CUSTOMER NAME		TEXAS INSTRUMENTS			ASSEMBLY TOP 1 of 2	
BOARD NAME			DESCRIPTION			
HIRES SINGLE DLPC900			Silkscreen - Top Side			
BOARD NO.	2513757	REV	DATE	PRJ#	SH OF	
		H	13 OCT 2020		17 21

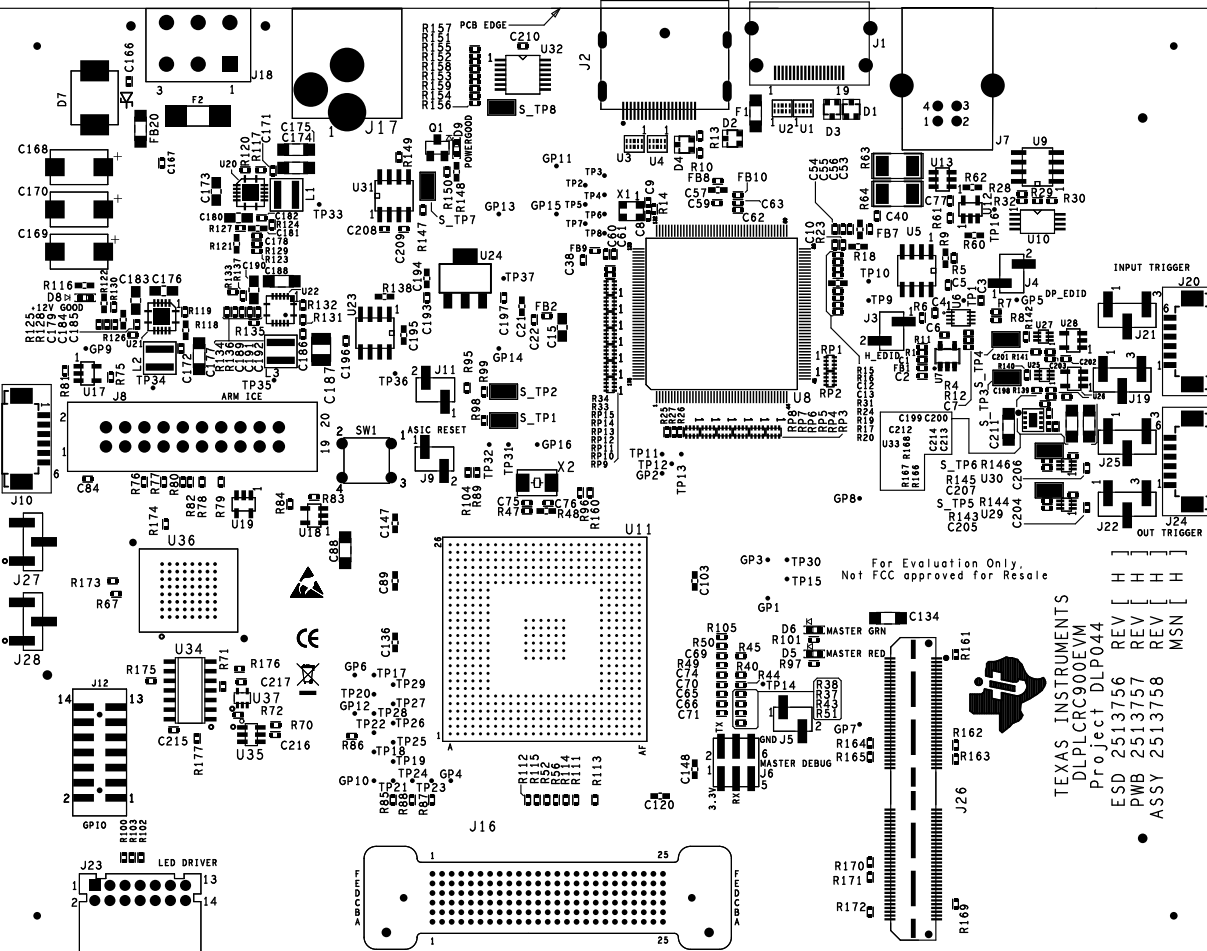
TOP PCB THICKNESS IS MORE THAN THE RECOMMENDED +4.0MM PASTEMASK FOR 2X SLOTS 1.7X0.6MM AND 2X 2.2X0.6MM BASED ON PCB THICKNESS.
